**REFERENCE: PROPOSED BOARDING HOUSE
77-79 WALDRON RD, CHESTER HILL NSW 2162**

ACCESS REPORT DEVELOPMENT APPLICATION

PROPOSED BOARDING HOUSE 77-79 WALDRON RD, CHESTER HILL NSW 2162

Document Type: Access Report

Figure 6 – Extract from Ground Floor Plan

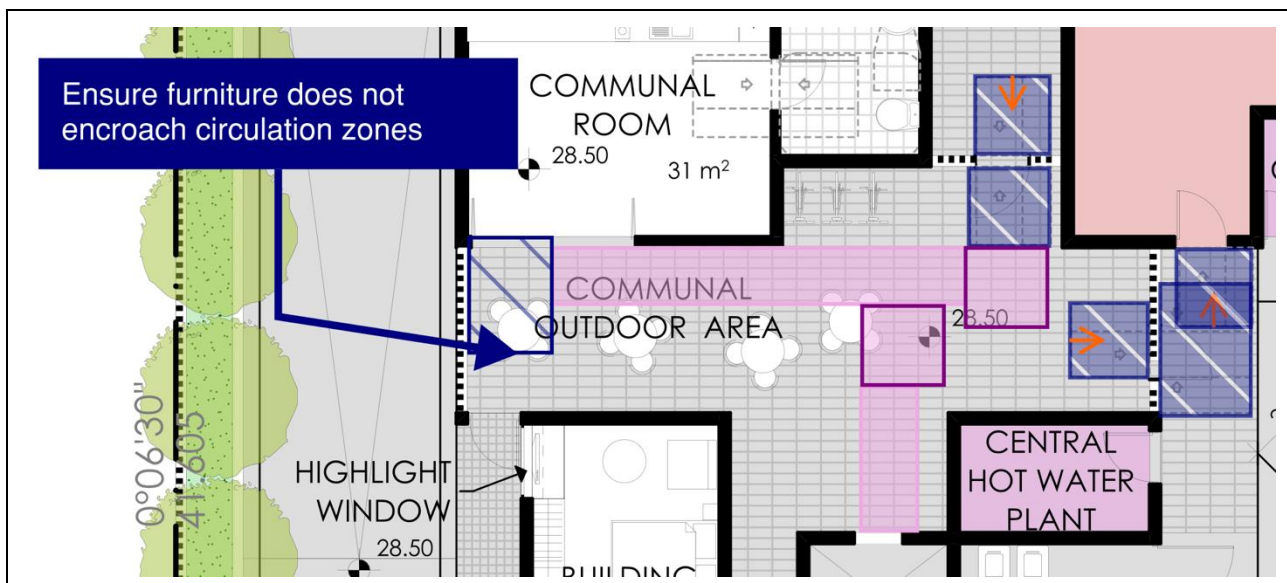
The building design requires locations where a wheelchair can make a 180deg turn (1540 x 2070mm) at corridor ends in accordance with the provisions of fig. 5, clause 6 of AS1428.1 2009 as well as 1240mm clearance in corridors outside office doors to comply with latch-side clearance requirements.

A 1500x1500 circulation zone will need to be provided where the path of travel changes direction.

Figure 11 – Extract from Ground Floor Plan

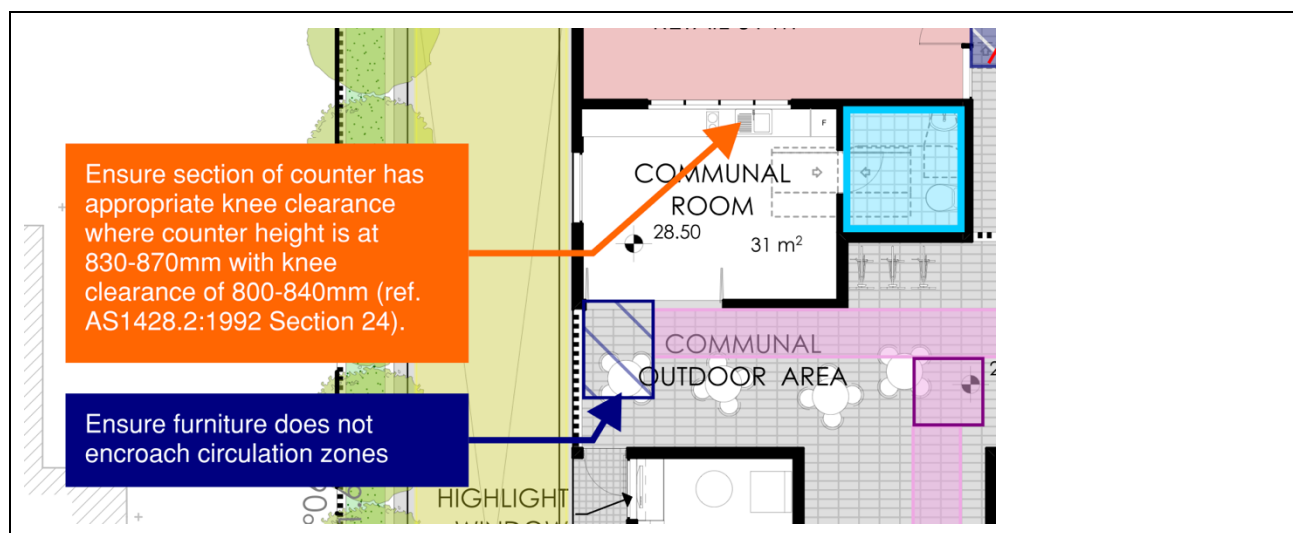
The kitchen counter within the Communal Room needs to incorporate a section of the counter suitable for wheelchair users. The detailing will need to comply with Clause 24 – Furniture and Fitments of AS1428.2.

Furniture layout plans will need to be provided to ensure accessibility is provided.

Figure 24 – Extract from Ground Floor Plan

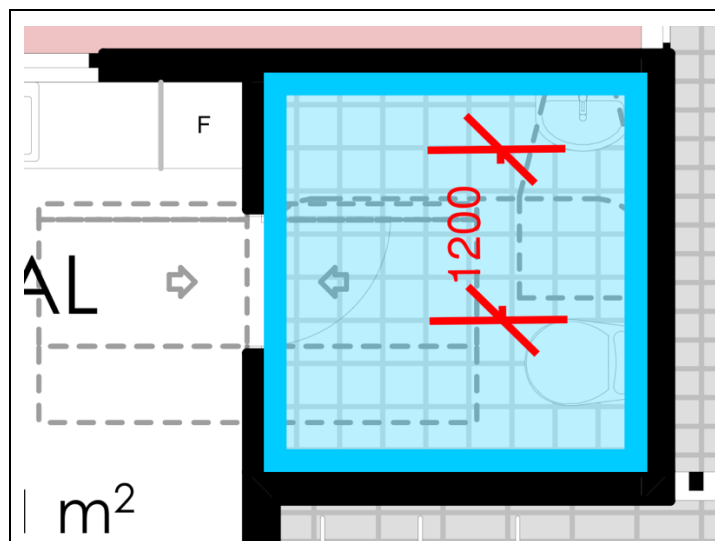
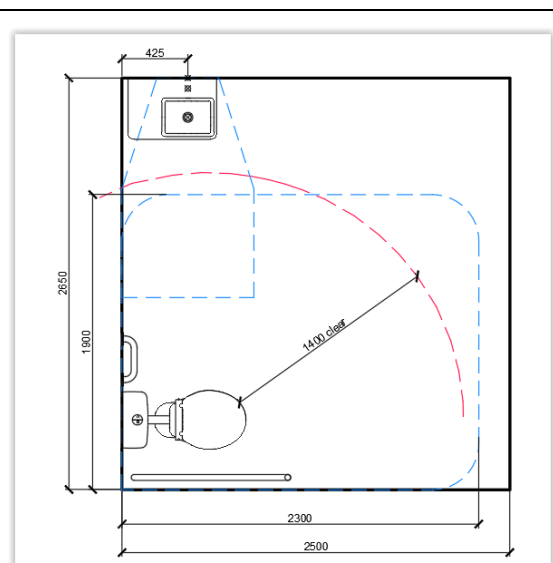
The ground floor USAT requires the toilet to be repositioned to ensure compliant circulation space, including 1400mm clearance from the toilet pan to other fixtures.

The toilets associated with the accessible rooms will need to be extended and redesigned to be in accordance with circulation requirements outlined in AS1428.1:2009. Extracts from SK01 and SK02 plans below:

Figure 25 – Concept sketch indicating layout compliant to the provisions of Clause 15 of AS1428.1:2009

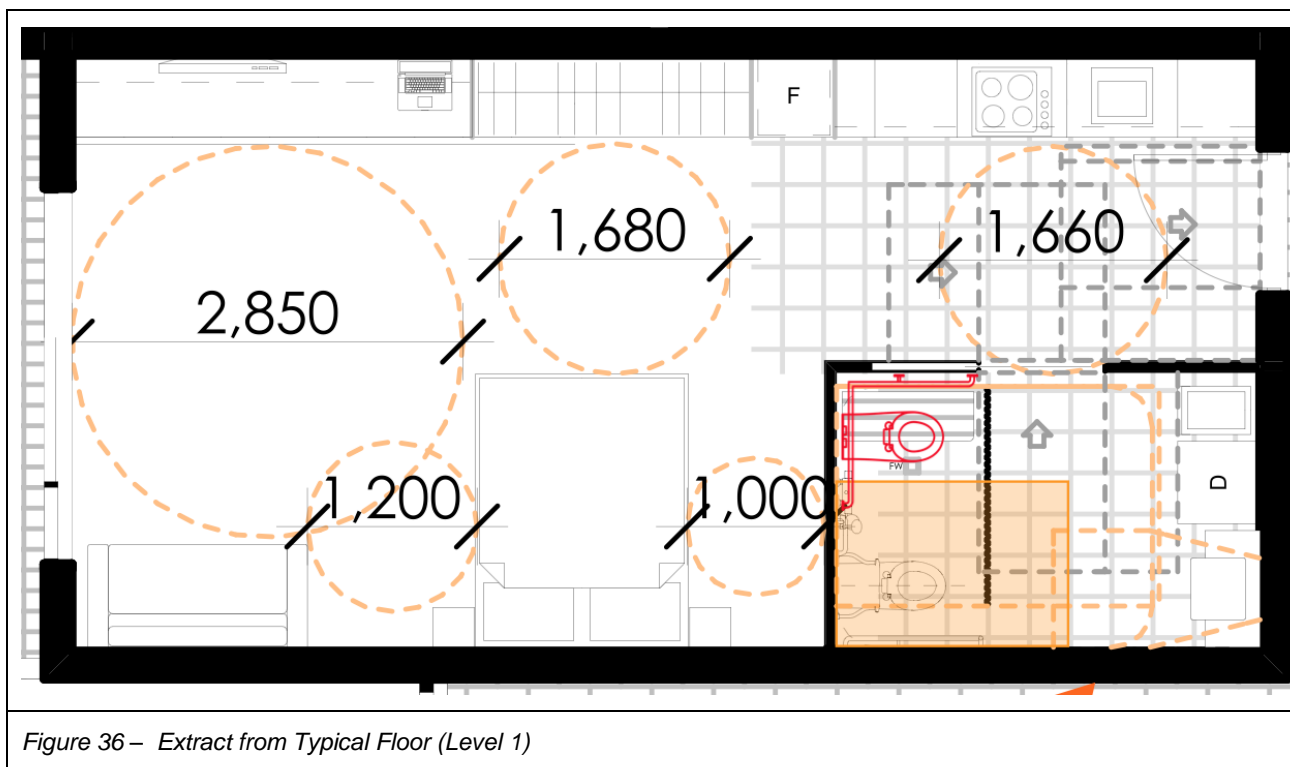
This plan proposes to locate the required 3 SOUs over all levels (1, 2 and 3) of this development, all of which are studio-style units, in line with the offerings of the other room types.

Reconfigure toilet and shower in accessible units to allow for a 1160 x 1100mm shower zone:
